**GLADSTONE PLANNING COMMISSION REGULAR AGENDA
GLADSTONE CIVIC CENTER, 18505 PORTLAND AVENUE
Tuesday, April 18, 2023 – 6:30 p.m.**

REGULAR AGENDA

The planning staff recommend approval of the Design Review application DR-23-03 and recommend the following findings and standard conditions in support of approval, as well as 4 special conditions: (1) Watts St Improvements; (2) Easements; (3) Sanitary Sewer Scoping; and (4) Oak Lodge Condition.

SITE & UTILITY PLAN
SCALE: 1/4" = 1'-0"

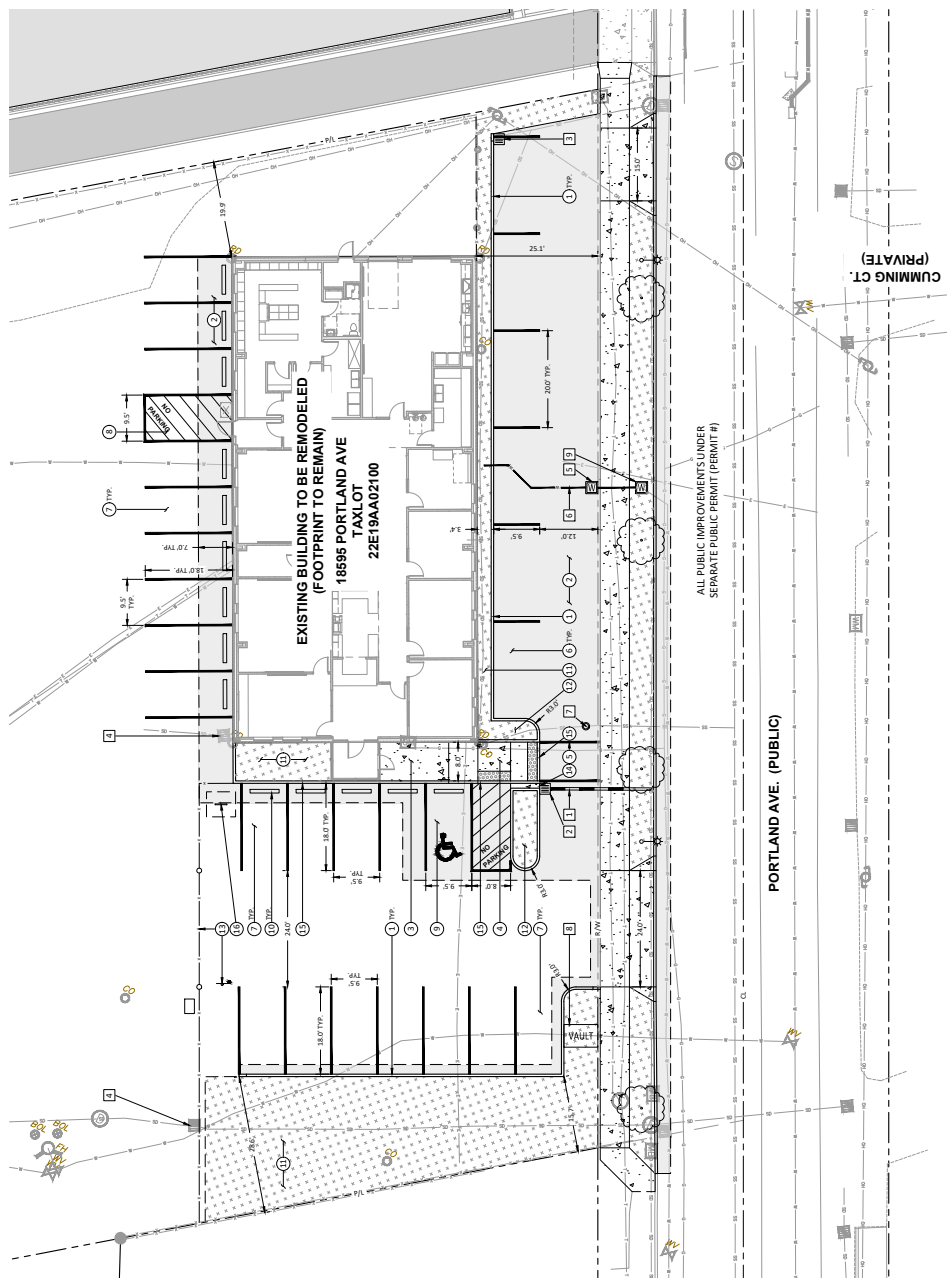
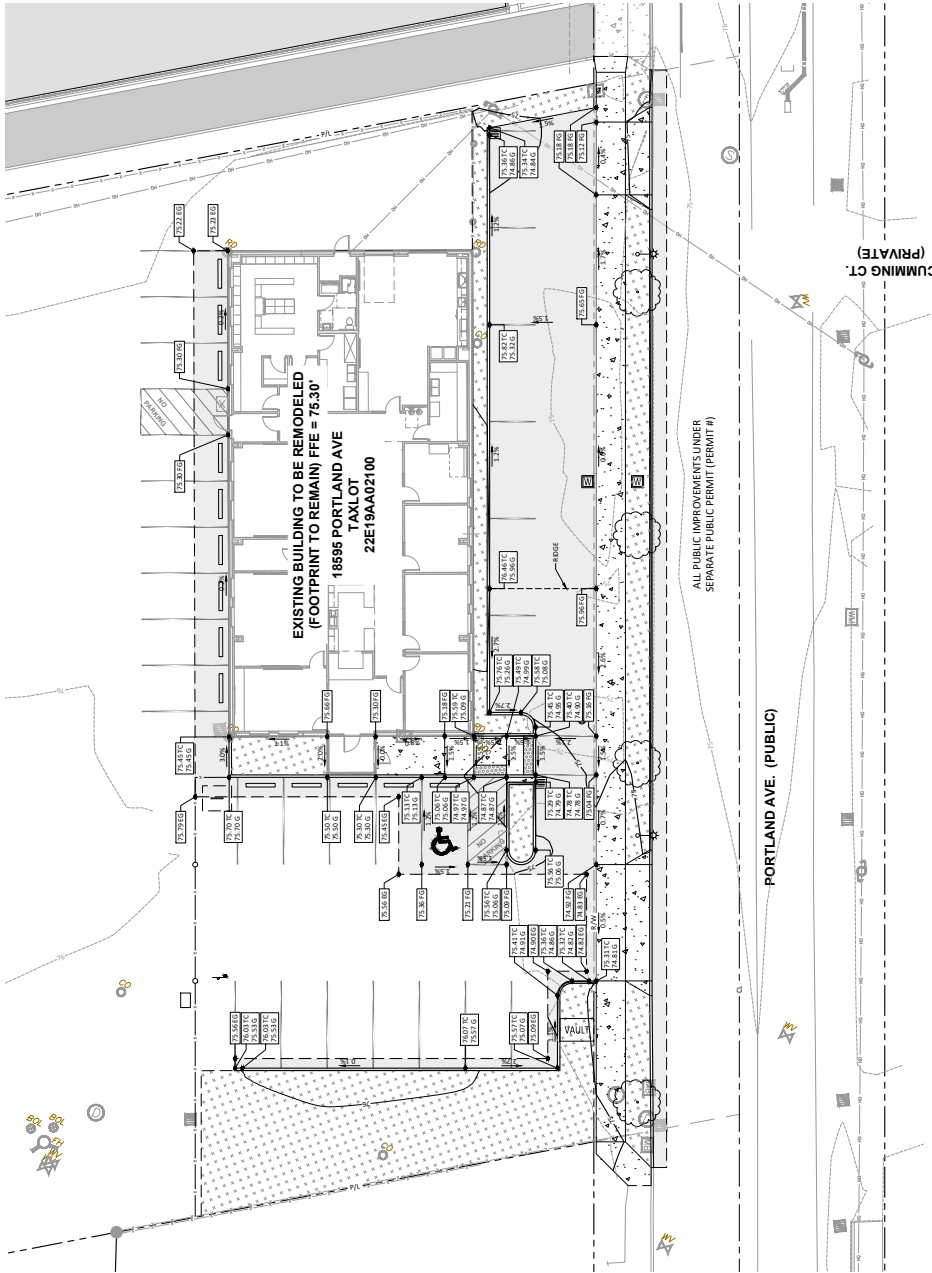
1. The water meter shall be moved into the planter strip during construction, consistent with Public Works Design and Construction Standards.
2. Water meter sizing calculations, typically based on fixture count, shall be submitted to verify adequate water meter size.

4. The project will be required to scope the sanitary lateral and provide a copy of the video to the Public Works Department for review. If the condition of the lateral within the public right-of-way is poor, then that portion of the lateral shall be replaced. If the condition of the existing lateral within the public right-of-way is good, then the lateral can remain. In either case, a cleanout will be required to be installed on the sanitary lateral behind the public sidewalk.
5. All public sanitary sewer improvements shall be installed pursuant to the requirements of the Public Works Design and Construction Standards.

- b. A 5-foot planter strip is required. Street trees shall be installed in the planter strip as required by the Municipal Code.
 - c. A new 6-foot sidewalk is required behind the planter strip. The sidewalk shall be ADA compliant and shall conform to the existing sidewalk to the north and south ends of the site.

10. Public utility easements shall be provided along both street frontages. Easement width shall be 8-feet. Easements shall be prepared using an approved City of Gladstone easement form and a copy of the recorded easement shall be provided to the Public Works Department prior issuance of the approved plans and right-of-way permit.
